From: Nicole Floyd <nfloyd@ci.olympia.wa.us>
Sent: Friday, May 27, 2022 12:45 PM
To: Rothwell, Rebecca (ECY) <rebs461@ECY.WA.GOV>; Steinweg, Noll E (DFW) <Noll.Steinweg@dfw.wa.gov>; Clinton, Brandon C CIV USARMY CENWS (US) <Brandon.C.Clinton@usace.army.mil>; Shaun Dinubilo <sdinubilo@squaxin.us>; Middleton, Thomas (ECY) <tmid461@ECY.WA.GOV>; Serdar, Carol (ECY) <cser461@ecy.wa.gov>; Lawson, Rebecca (ECY) <rlaw461@ECY.WA.GOV>
Subject: FW: West Bay Yards

Re: West Bay Yards proposal

Thank you for providing the opportunity to comment on the second round of review for the West Bay Yards proposal. Based on our review of the documents provided on the City's website, we offer the following comments and recommendations, with more details outlined below:

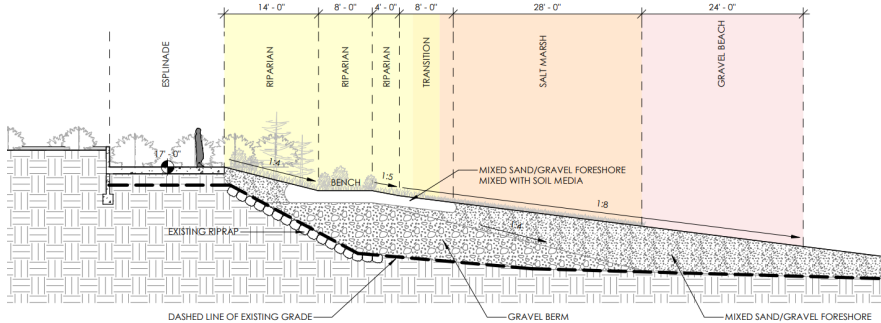
Ecology recommends that the applicant examine alternatives to the project-specific restoration plan in order to comply with the SMP’s mitigation sequencing requirements. For example, the letter from Landau Associates to Milestone Companies West Bay Development Group, dated October 29, 2021, looks at the estimated stability of the shoreline slope under existing and proposed conditions. Three conditions were analyzed with the resulting factors of safety (FS):

- Existing slope, static conditions, with riprap (FS = 1.5).
- Existing slope, static conditions, without riprap (FS = 0.7).
- Proposed slope configuration, static conditions (FS = 3.0).

Based on the results of the shoreline slope stability analysis, Landau does not recommend removing riprap, as doing so could undermine the stability of the slope. However, Landau did not look at other options, such as removing the riprap, or just the upper portion of the riprap, and grading a gradual slope landward of the remaining riprap. If this approach is viable, then the fill for the restoration could start at a lower elevation, resulting in less conversion of area below the OHWM to uplands.

There appear to be other opportunities for the applicant to minimize the amount of fill and hence and the amount of area converted to uplands. For example, in the figure below, which is from Sheet A103 of the site plans in the Design Review Packet, the bench is horizontal and extends the fill eight feet waterward. The bench does not appear to advance the goals of the restoration project. This bench could be eliminated, shifting the transition zone, salt marsh, and gravel beach landward. This would minimize fill and reduce impacts to the aquatic environment.
